From: Ben J. Arguijo <bjarguijo@basinenv.com>
Sent: Tuesday, October 22, 2013 10:40 AM
To: Bratcher, Mike, EMNRD
Subject: North Indian Flats 26 Fed. #1 (2RP-1624)
Attachments: NIF_FieldSketch.pdf; NIF_Trenches_Aerial.jpg

BOPCO, LP
NORTH INDIAN FLATS 26 FEDERAL #1
EDDY COUNTY, NEW MEXICO
NMOCD REFERENCE #: 2RP-1624

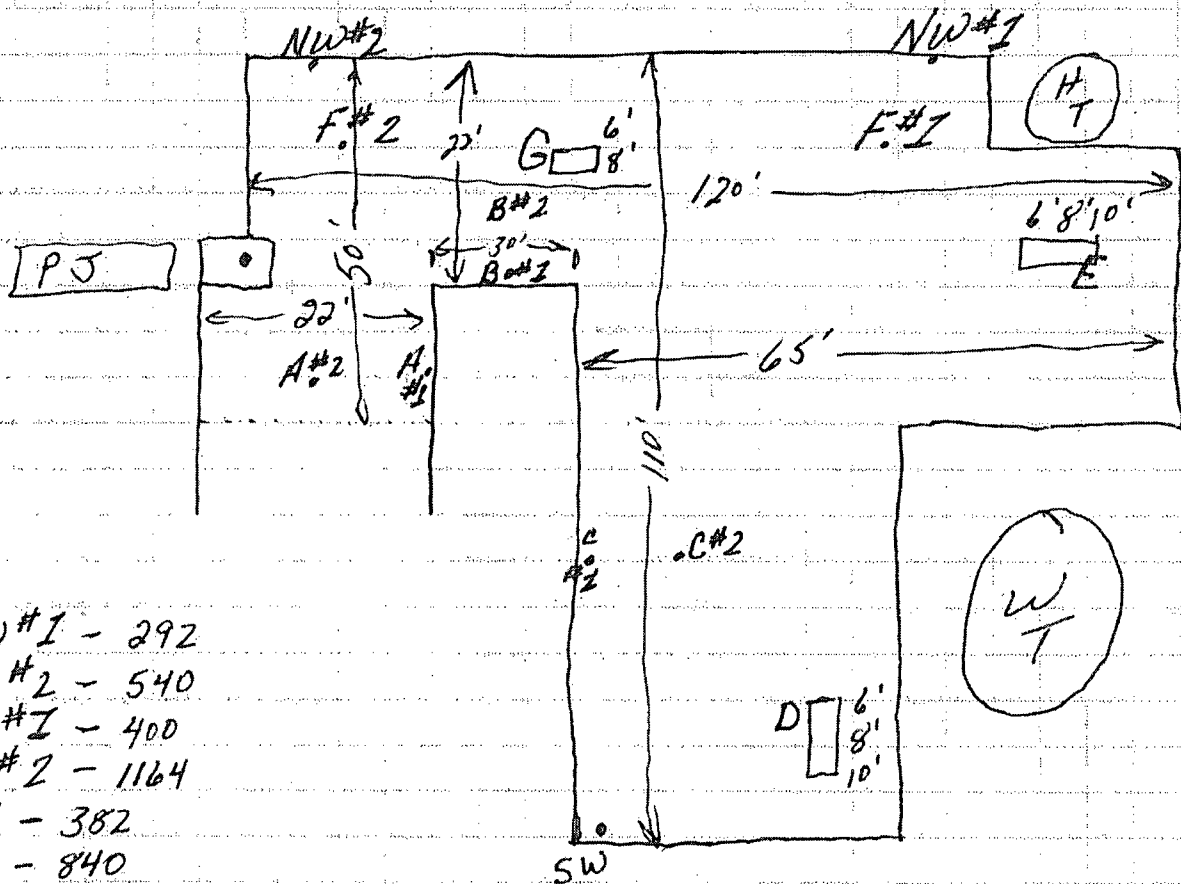
Trench D is to the south of the excavation, near the on-site produced water tank. We have a lab sample collected from the trench at 6' bgs with a chloride concentration of 3,160 mg/kg, but we have field-screen results at 8' and 10' that are 204 and 260 mg/kg, respectively. Obviously, the wrong sample was submitted to the lab. However, the 8' and 10' samples were evidently dumped out at the site on the day of collection, so we can't submit them for analysis. Will the field-screen results be sufficient since this is a risk-based closure, or do we need to attempt to collect an additional sample below the liner at 8' - 10' bgs to submit for laboratory analysis?

Trench E is in the area between the on-site produced water tank and heater treater. A sample collected at 10' bgs was submitted to the lab for analysis and showed a chloride concentration of 1,650 mg/kg. We can demonstrate a "downward trend", as the field-screen at 6' bgs was 3,764. Is this sufficient, or will we need to advance a soil boring at/near this location to delineate below 1,000 mg/kg (or less)?

Trench G is in the northwestern portion of the excavation, near an active pipeline bordering the release to the north. We have no lab results from this trench due to a miscommunication in the field. Field-screens were 3,764 mg/kg at both 6' and 8' bgs. Floor samples (B#1, B#2, and Floor #2) collected nearby (see attached field sketch) were submitted to the laboratory for analysis and demonstrated chloride concentrations below 1,000 mg/kg. The nearest sample, B #2, had a chloride concentration of 96.0 mg/kg. That said, will we need to advance a soil boring at/near the location of Trench G?
